Date: April 13, 2020
To: Planning Board
From: Kellie Walsh, Town Planner
Subject: **Savage Farm LLC (owner/applicant)** – Review for acceptance and consideration of final approval for a major site plan to maintain an existing two-family building in its current use and configuration, renovate and re-purpose the barn into retail use antiques center, and to develop the rear of the property into a natural materials processing/storage area with space for equipment storage and maintenance structure associated with materials processing. The parcel is located at 475 Elm Street in the Integrated Commercial-Industrial District, West Elm Overlay District, Groundwater Protection and Floodplain Management Districts. Tax Map 7, Lot 7.

Re: Savage Farms Site Plan, 475 Elm Street (Map 7, Lot 7) – Drainage Review

**Re: Interdepartmental Review Map 7 Lot7
Savage Farms LLC Multiuse Development**

EXISTING CONDITIONS PLAN
LAND OF
SAVAGE FARMS, LLC
TAX MAP 7 LOT 7 475 ELM STREET
MILFORD, NEW HAMPSHIRE

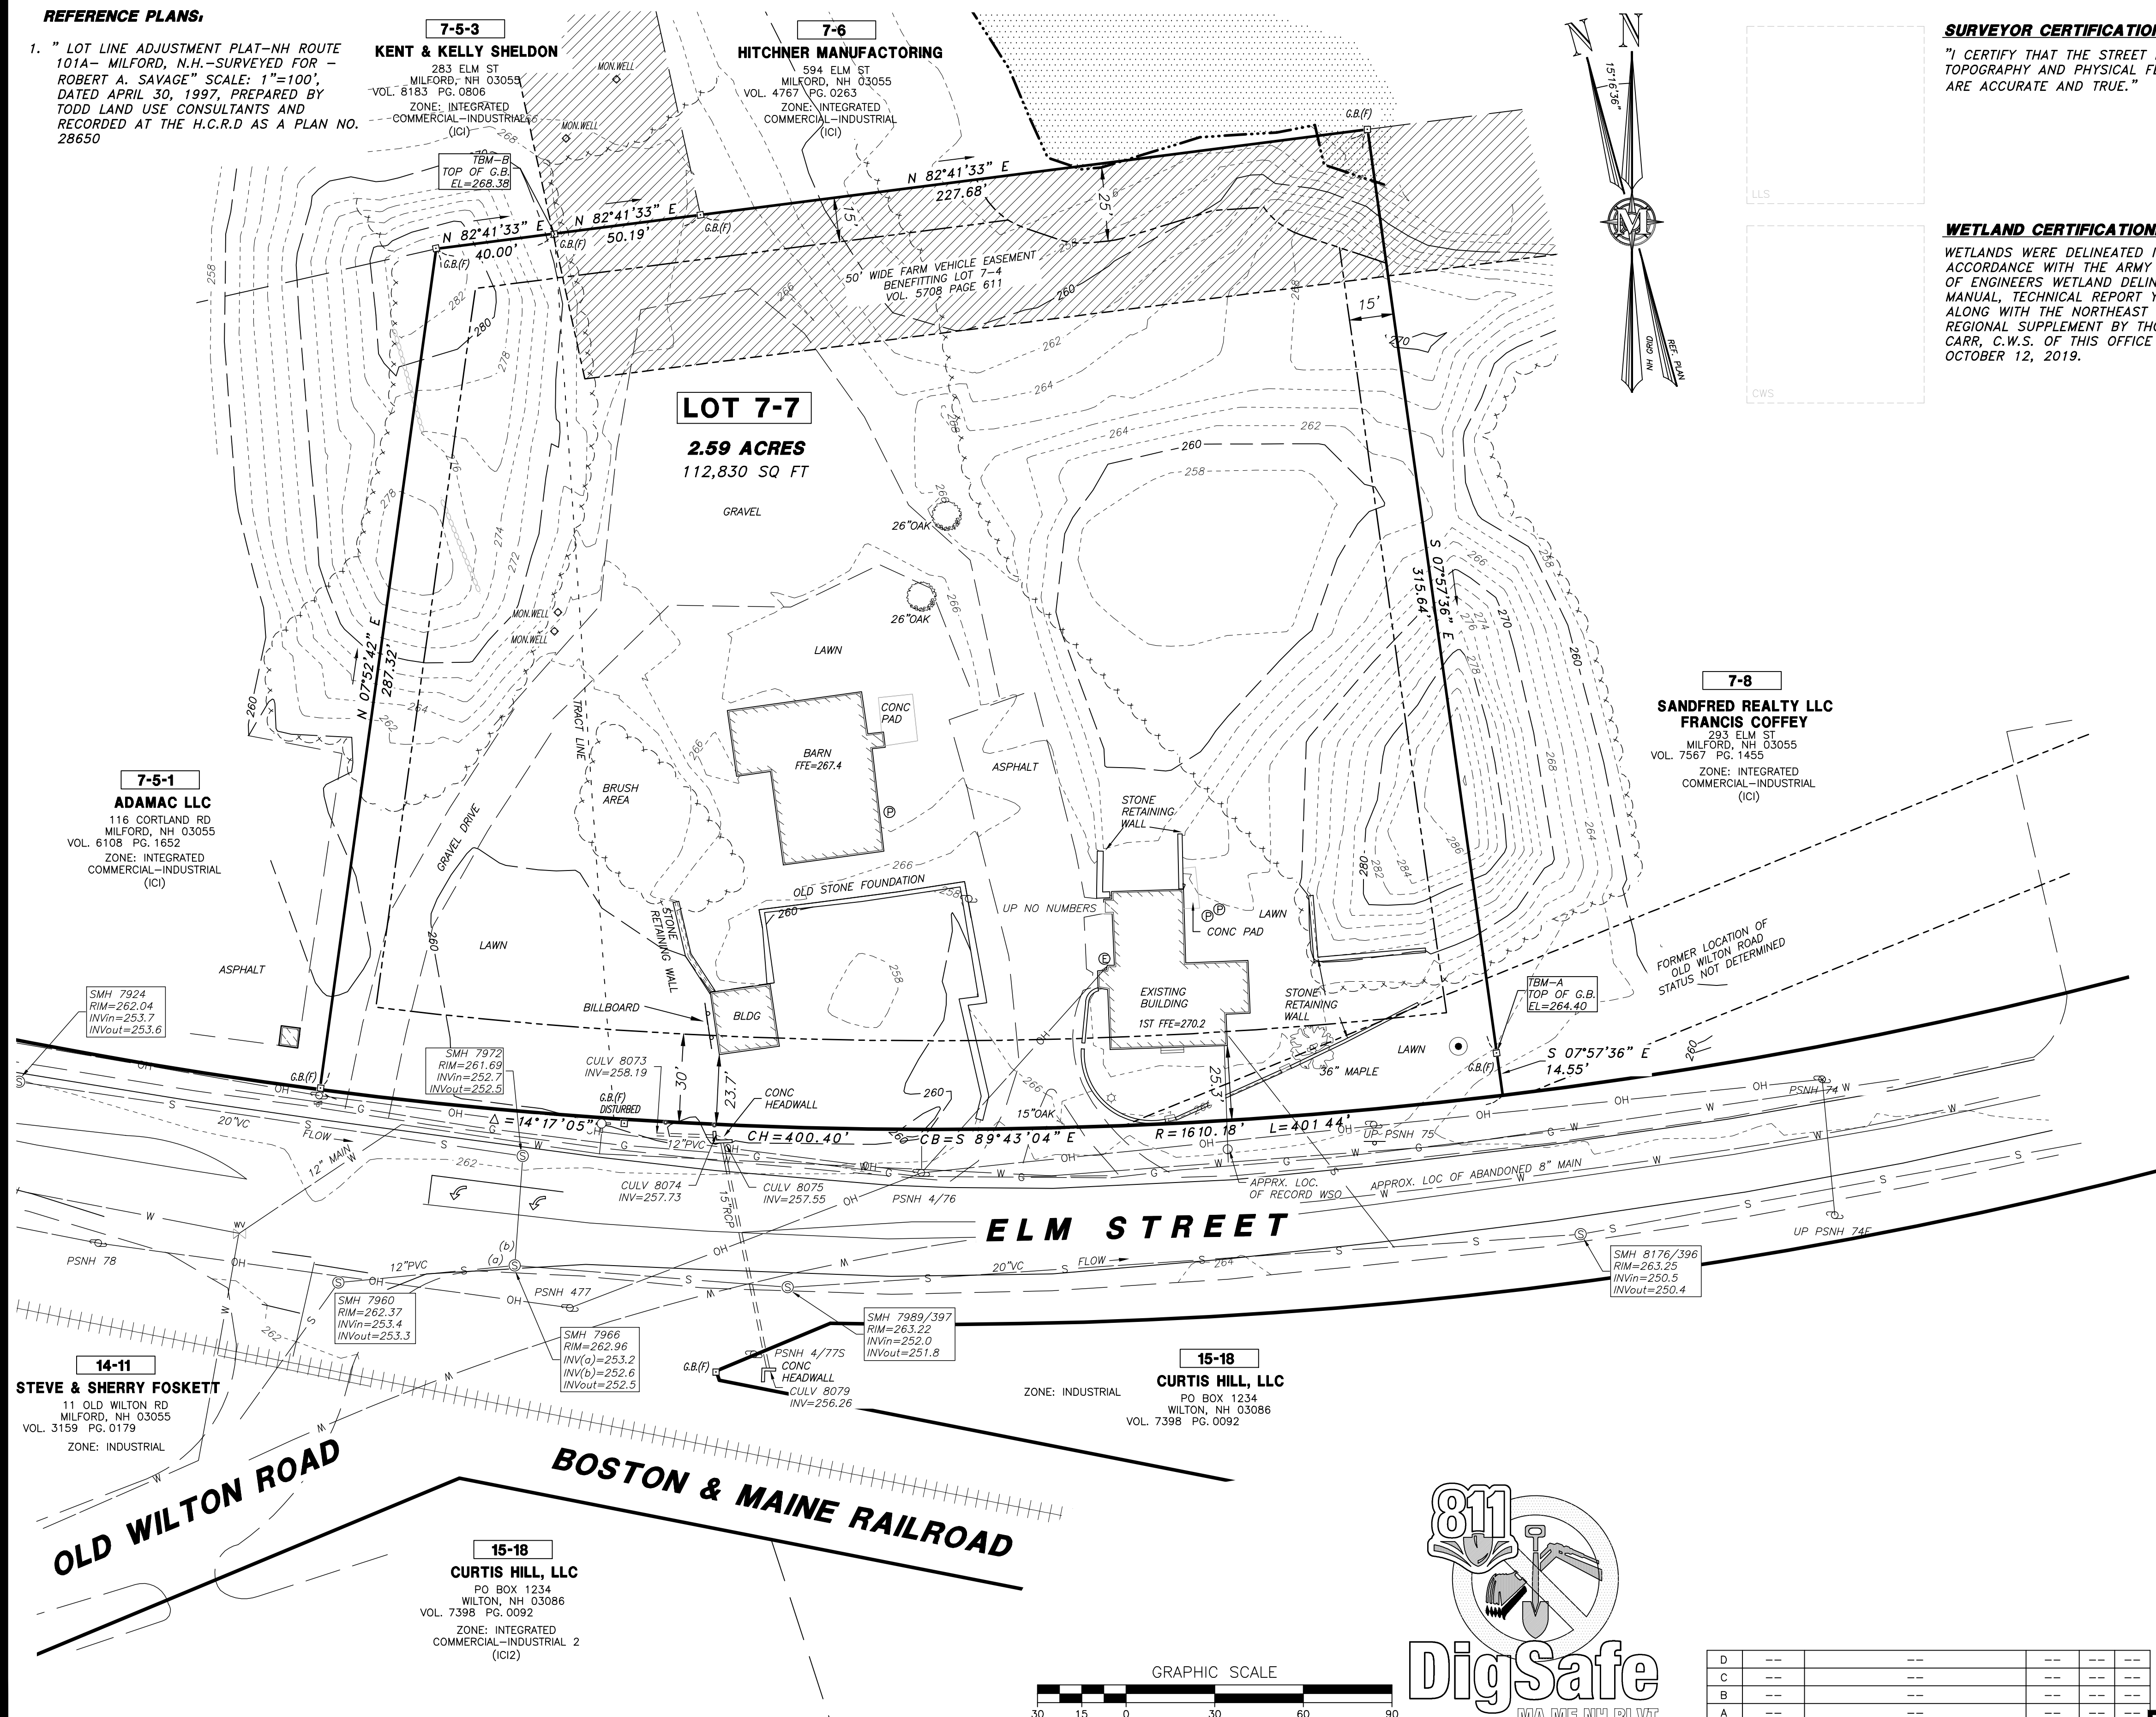
1. Existing Conditions. Sheet 3. Two monitoring wells are shown on the western portion of the site. Please explain.
2. Site Plan Layout. Sheet 4. A concrete dumpster pad is proposed within the farm vehicle easement benefiting lot 7-4. Documentation will need to be provided stating permission has been received from the easement holder to place the concrete pad.

5. Landscape Plan. Existing landscaping is shown on the existing conditions (sheet 3) and the site plan layout (sheet 4) shows some proposed treeline, however a separate landscape plan was not included in the plan set.

MULTI-USE DEVELOPMENT
SAVAGE FARMS, LLC
475 ELM STREET
MAP 7 LOT 7
MILFORD, NEW HAMPSHIRE
SCALE: 1" = 30'
MARCH 23, 2020
SITE LAYOUT PLAN
SP-3
SHEET
FILE: 852100A.dwg
PROJECT: 852.20
SHEET NO. 4 OF 10

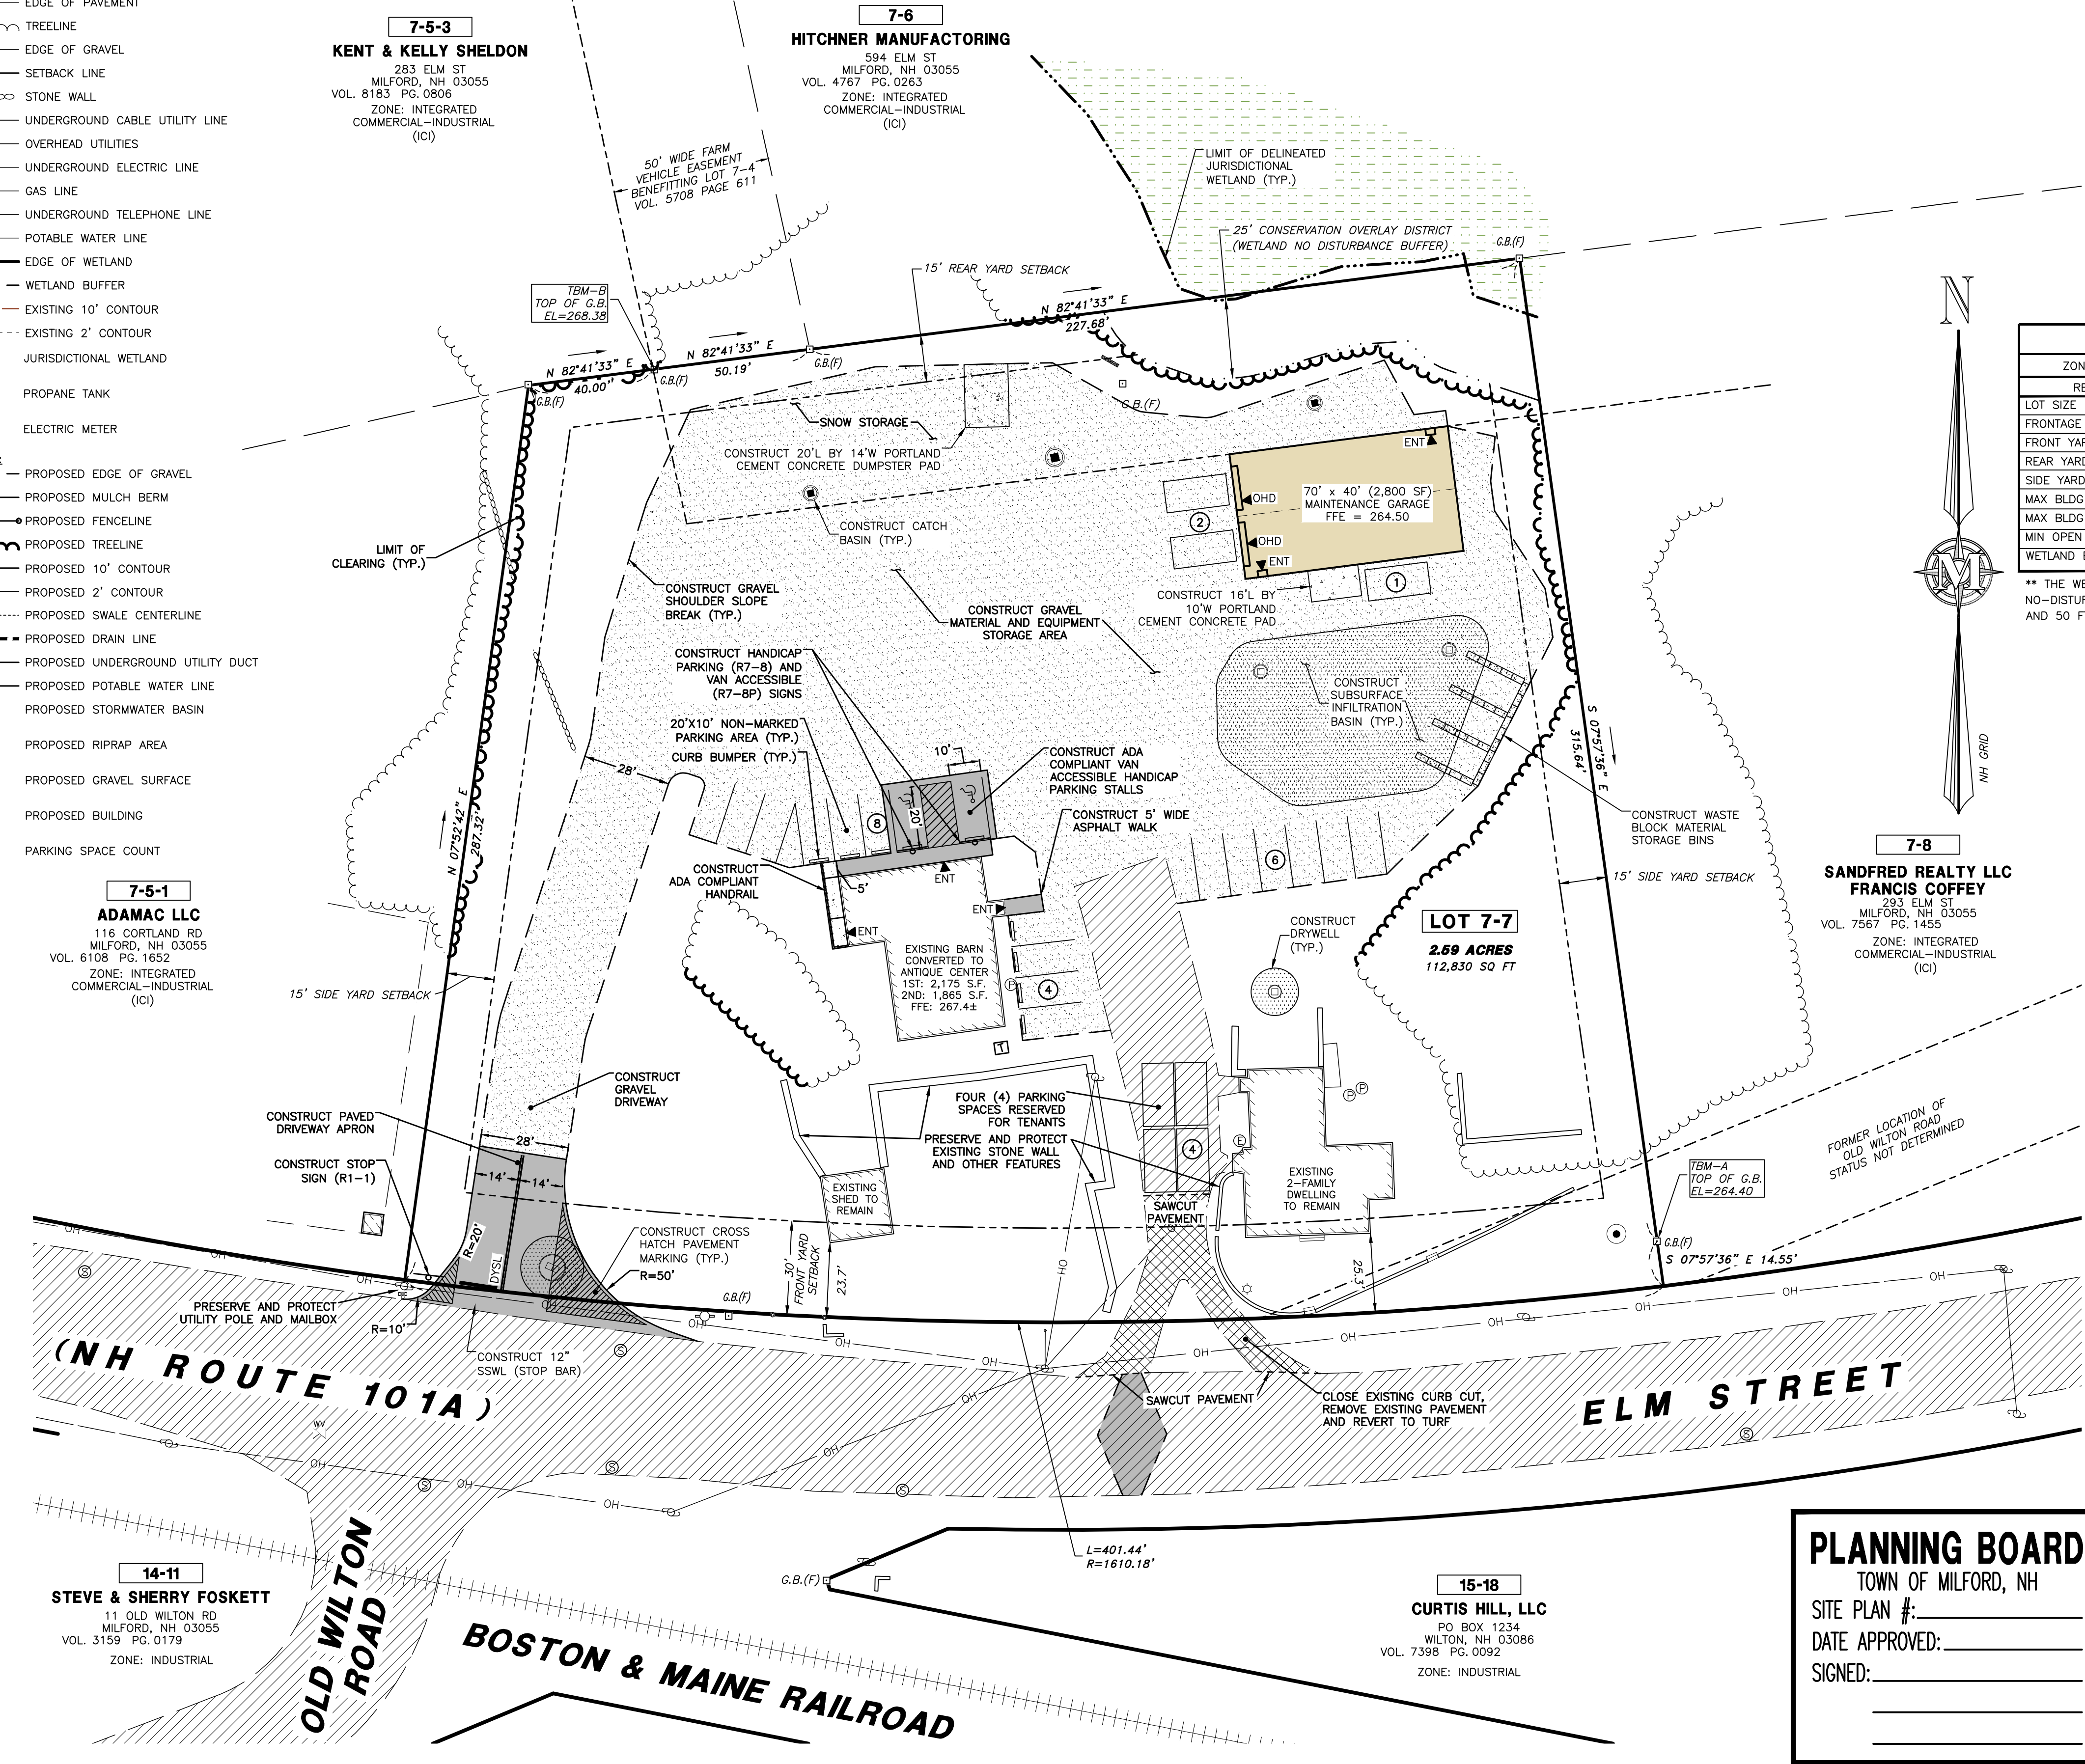
3. Site Plan Layout. Sheet 4. A gravel material and equipment storage area is shown in the central portion of the site/to the west of the proposed maintenance garage. Please more clearly define this area (i.e. show a defined outline of where equipment will be stored).

4. Site Plan Layout. Sheet 4. There is striping at the proposed entrance (cross hatching). Please explain the purpose and if it is acceptable to NHDOT.

- a. Please revise the plans to include a landscape design in compliance with the Development Regulations and Zoning Ordinance, Section 6.07 West Elm Street Gateway District (and associated West Elm Street Gateway District Design Guidelines) or submit a waiver (with narrative) seeking relief from the said section.

SUBSURFACE INFILTRATION BASIN
 (NHDOT ITEM NO.)
 MAR. 23, 2020
 SCALE: NONE **D-2**

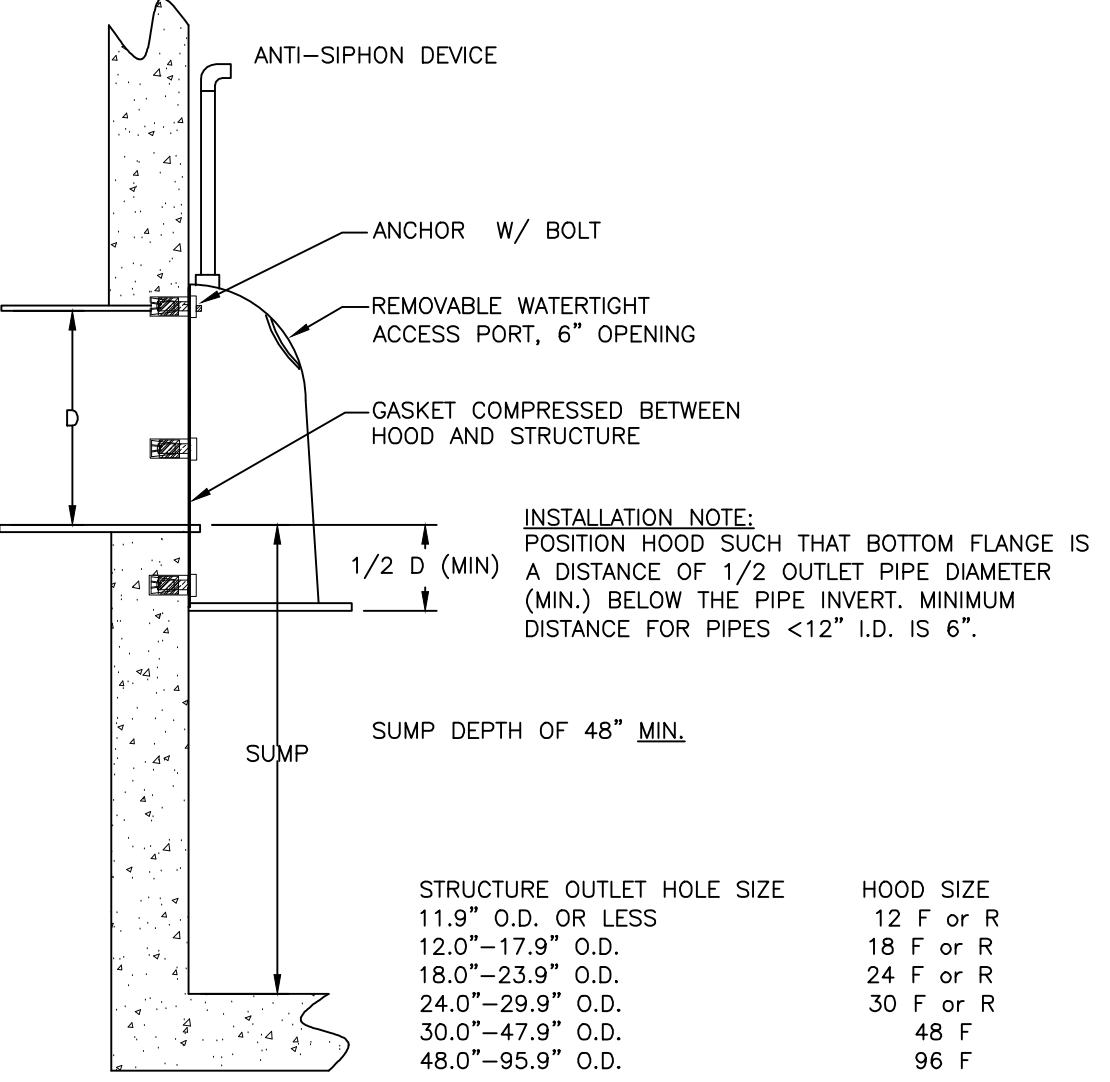
3. Note that the large stone area has stone that extends up to elevation 262.00 and the maximum water surface elevation below and outlet is 258.45 (Basin #2 overflow) making the top 3.5 feet of stone ineffective for stormwater control.

4. The large stone area requires a substantial amount of lateral flow movement from the drywells to the edge of the stone to engage all the stone in the infiltration area. Lateral pipes from the dry wells are required to ensure the entire area is effective for infiltration.

PRECAST CONCRETE DRYWELL
 (PHOENIX PRECAST PRODUCTS)
 MAR. 25, 2013
 SCALE: NONE **D-2**

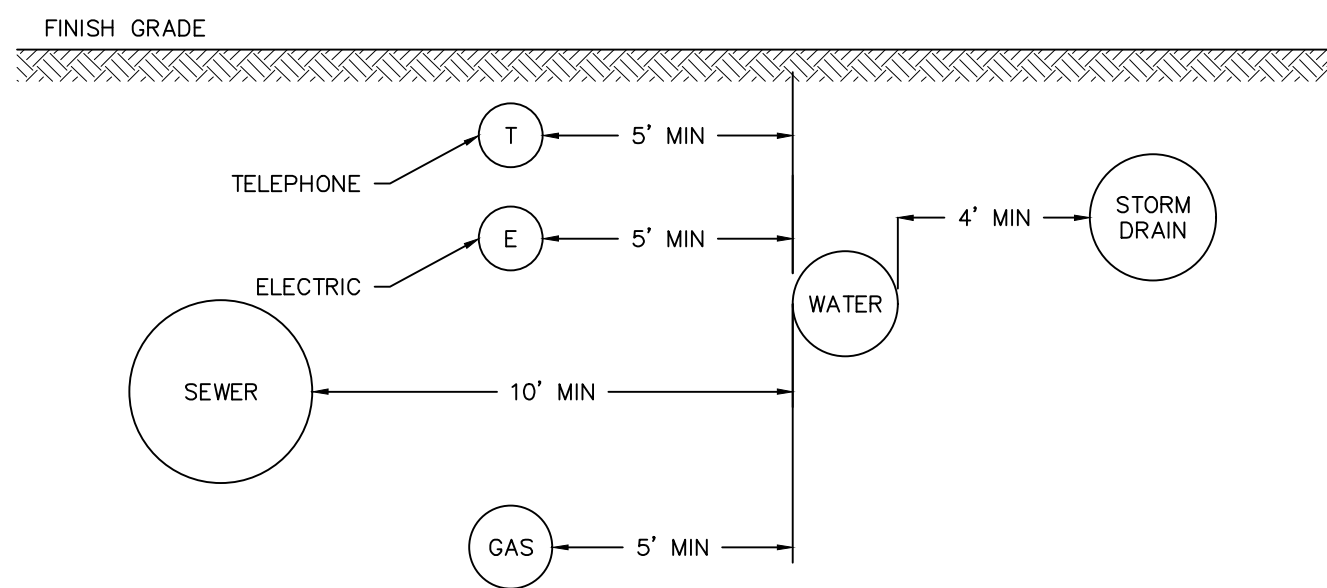
2. Drywell #1 and #2 is proposed to be placed on undisturbed ground with no stone below the precast unit. Typical construction methods for installing precast drywells with no bottom slab are to install them on crushed stone. (like #3 and #4). Please clarify why this was proposed and if the soils below can support the structure on only the side walls.

5. It appears that Drywell #4 is located within the water table. Test Pit #5 indicates a water table about 3' below the surface. The drywell is in a location where the existing ground elevation appears to be at about elevation 261.00 making the water table at about 258.00. The bottom of the drywell stone and effective infiltration area in the calculations is at elevation 253.63. Please clarify and revise as necessary.

6. There appears to be no test pit in the vicinity on Drywell #3 (TP-3 not found). The bottom of

the stone is about 5.5 feet below the surface. Clarify how was the water table was determined or assumed in this area to ensure the drywell bottom will be above it.

7. Clarify where catch basin hoods will be used (assume all catch basins) by a note on the plans.
8. Specify the cover or inlet type for the proposed drywells.
